CPED STAFF REPORT

Prepared for the City Planning Commission
CPC Agenda Item #1
November 16, 2015
BZZ-7408

Project Name: Mount Olivet Careview Home Addition

Request: To construct a 36,184 square foot addition to an existing board and care home/assisted living facility.

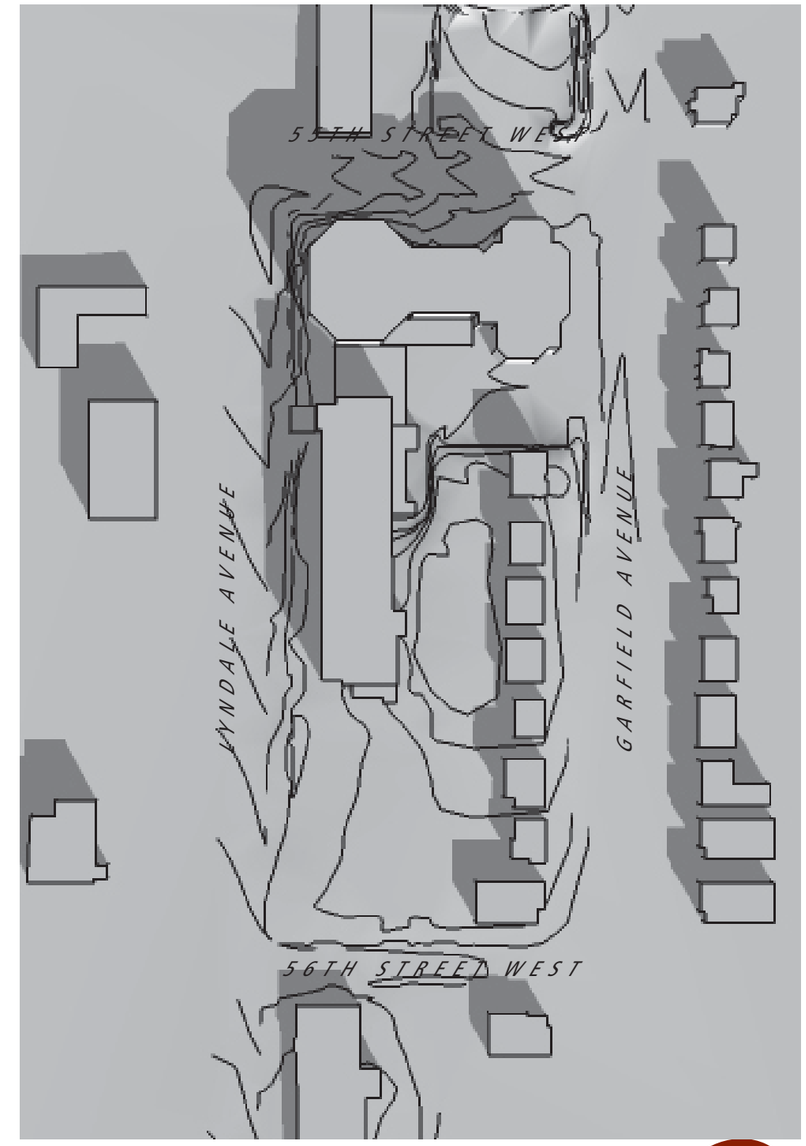
2. *Shadowing of residential properties, significant public spaces, or existing solar energy systems.*
   The applicant submitted shadow studies of existing conditions and shadowing impacts with the proposed addition. The shadow studies show that with the addition, there are no significant changes to shadowing on adjacent residential properties. This is primarily due to the fact that adjacent residential uses are southeast of the proposed addition. There are no significant open spaces nearby and no known solar energy systems near the site.
